UNITED STATES PATENT AND TRADEMARK OFFICE

09/934,178

Office Action Summary	Application No. 09/934,178	Applicant(s) BROWN ET AL.	
	Examiner Paul B. Prebilic	Art Unit 3774

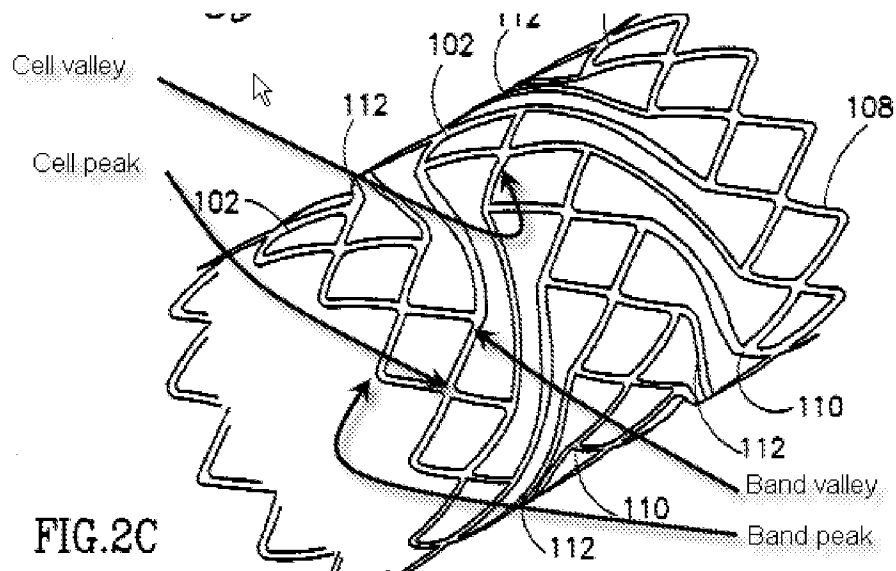
Pinchasik meets the claim language where the peaks of adjacent ends of the cell are clearly offset; see Figures 2A to 2C. Each cell has two cross supports between a cell peak or valley and a band peak or valley. There are serpentine band peaks and valleys and there are cell peaks and valleys; see the figure below.

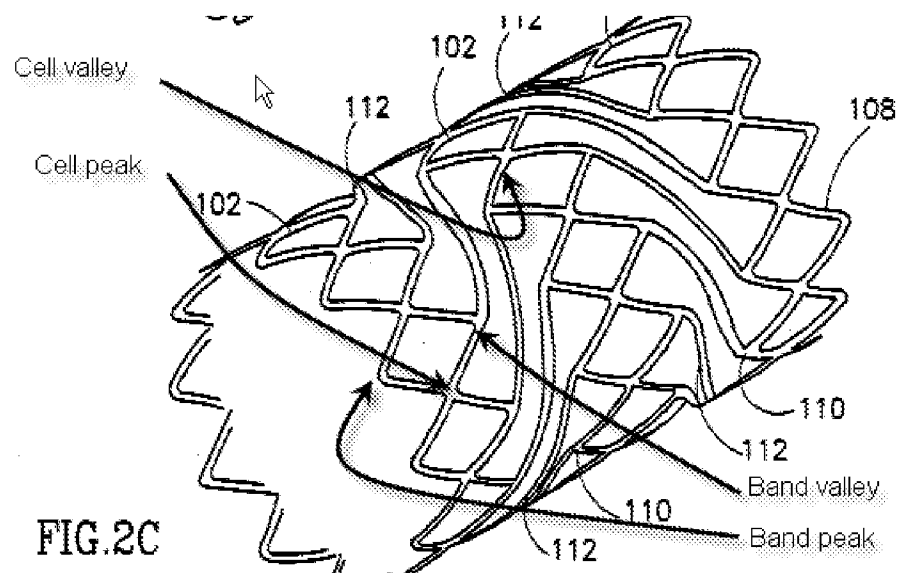
Claims 16, 25-26 and 28 rejected under 35 U.S.C. 103(a) as being unpatentable over Pinchasik et al (US 5,449,373) in view of Kleshinski (US 5,902,317). Pinchasik meets the claim language where the peaks of adjacent ends of the cell are clearly offset; see Figures 2A to 2C. There are serpentine band peaks and valleys and there are cell peaks and valleys; see the figure below.
